Subject: RE: 1RP-4636 Hamon Tank Battery Delineation Plan

Larson & Associates, Inc. (LAI), on behalf of Legacy Reserves Operating, LP (Legacy), submits the attached delineation plan for a produced water spill at the Hamon Tank Battery (1RP-4636) in Lea County, New Mexico. Your approval of the delineation plan is requested. Please feel free to contact Brian Cunningham with Legacy at (575) 391-1464 or bcunningham@legacy.com, me at (432) 687-0901 (office) or (432) 664-5357 (cell) or Mark Larson if you have any questions.

Figure 4 - Recent Aerial Map with Proposed Sample Points

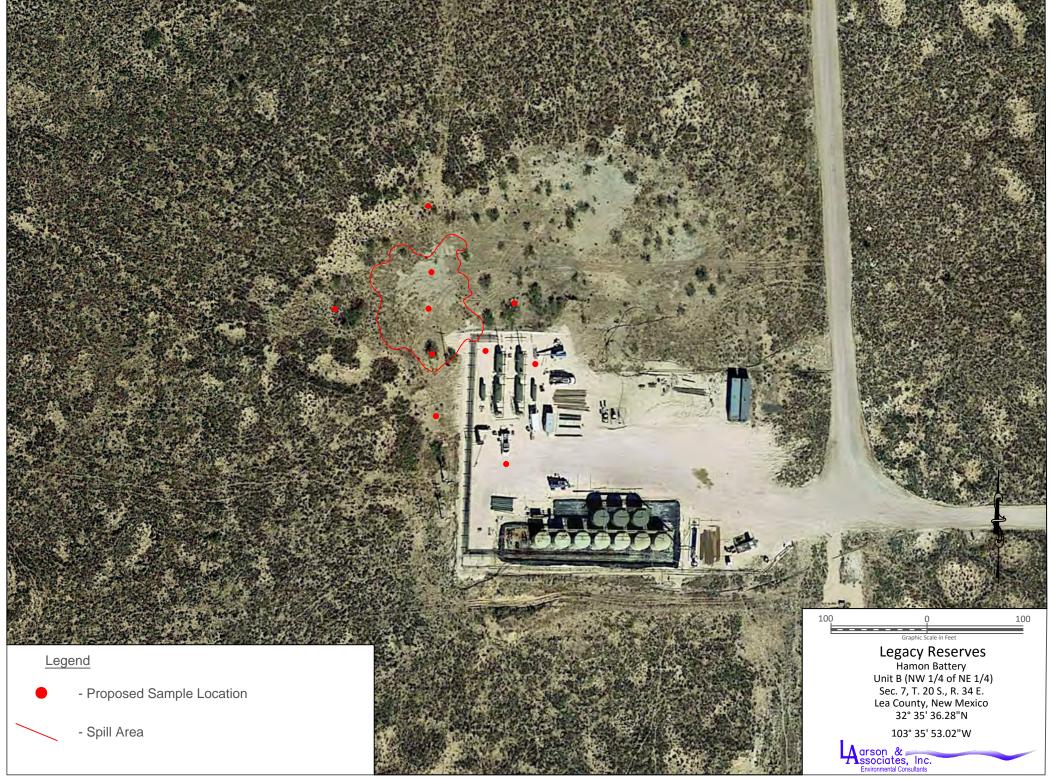
NMOCD approves of the proposed delineation plan for 1RP-4636 with the additional delineation locations as indicated below. Please remember to mark the release location on a scaled map in the next report.

Condition: Please address this concern regarding the proposed delineation plan for 1RP-4636. The initial C-141 stated that the release area was around the separator. Please provide a rationale why all except one of the delineation sample locations are located in the pasture.

Please address this concern regarding the proposed delineation plan for 1RP-4636. The initial C-141 stated that the release area was around the separator. Please provide a rationale why all except one of the delineation sample locations are located in the pasture.

Response: The separator was located near the northwest corner of the pad and the majority of the liquid flowed northwest off the pad and pooled in the pasture. LAI has included a soil sample near the northwest corner of the pad in close proximity to the former separator. Legacy removed the separator following the incident and scraped visibly contaminated soil from the pad. LAI was called in to complete the delineation after Legacy rebuilt the tank battery. Equipment is now located over the area. LAI is proposing to collect soil samples at three (3) locations around the equipment where access is available for the direct push rig. LAI will also delineate the area where liquid polled in the pasture northwest of the pad.
